Service Information Letter

Document 159-052-00

Subject: CMM update to cam inspection requirements and acceptable cam surface cleaning process at overhaul

Figure 9.2.1

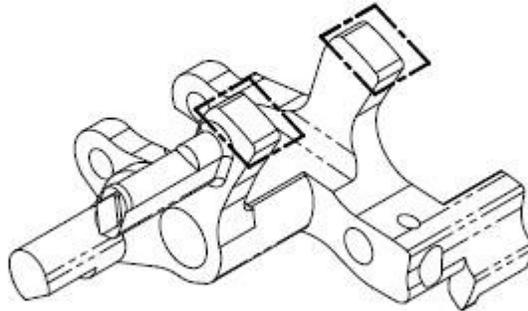
It is critical that the cam surface shown in Figure 9.2.1 (next page) be maintained according to the criteria specified in the CMM in order to ensure that the cargo hook both retains a load and opens within the acceptable ATP tolerances. Damage to this surface may result in a higher force required to open the hook, while rework of this surface (material removal), may result in a lower threshold for opening the hook. Since both of these scenarios could result in hook release performance outside of acceptable ATP tolerances, Onboard has updated the cargo hook CMM to include a visual inspection for damage (including wear, dents, corrosion, gouges, or nicks), a cleaning process to be used for these surfaces, and a circularity tolerance of 0.001” for these surfaces (see Figure 9.2.3). Onboard Systems recommends the use of a coordinate measuring machine or articulating inspection arm to record this measurement. Any cams exhibiting visual damage or measuring outside of the circularity tolerance should be replaced at overhaul. As such, Onboard is adding the cam to our standard overhaul kits. There is no change to the design, weight, fit, form, or function of the cam related to the revision of this maintenance procedure.

Thoroughly inspect surfaces inside lines for signs of visible wear, dents, corrosion, gouges or nicks. Continued use of a damaged cam may cause inadvertent load release.

Repair (including filing, deburring and buffing) is prohibited on all surfaces shown inside lines. Alterations of these surfaces may cause inadvertent load release.

Figure 9.2.2

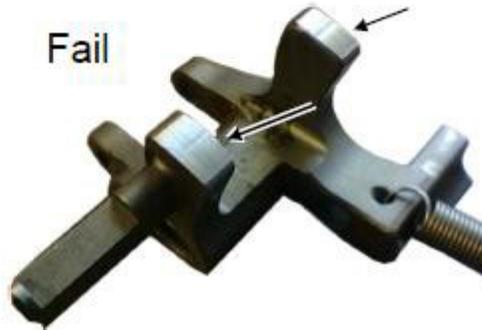
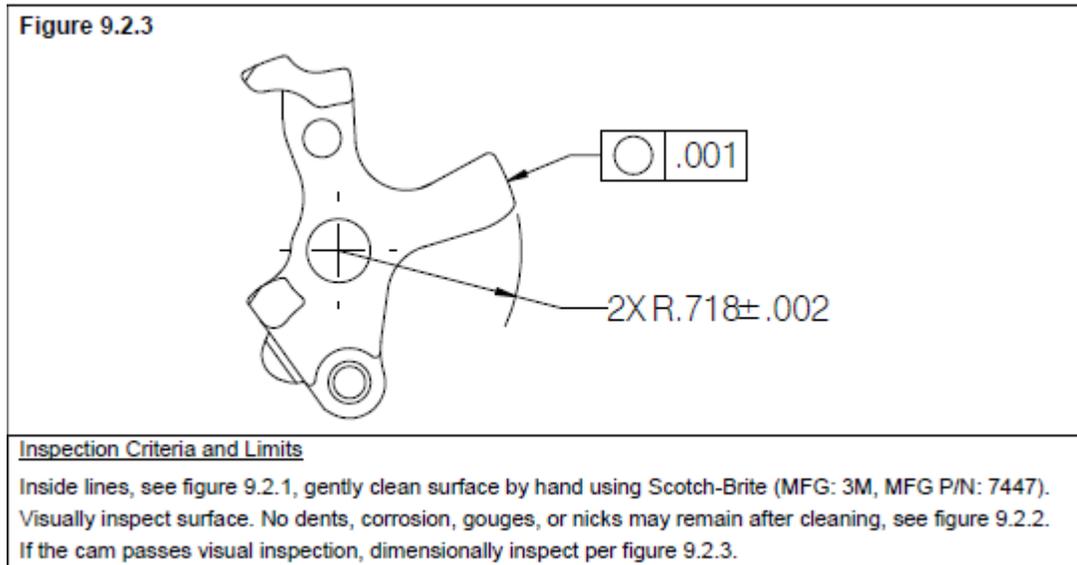
The following pictures illustrate the updated CMM content associated with cam inspection requirements and surface cleaning process:

Figure 9.2 Cam Assembly (3) Inspection Criteria
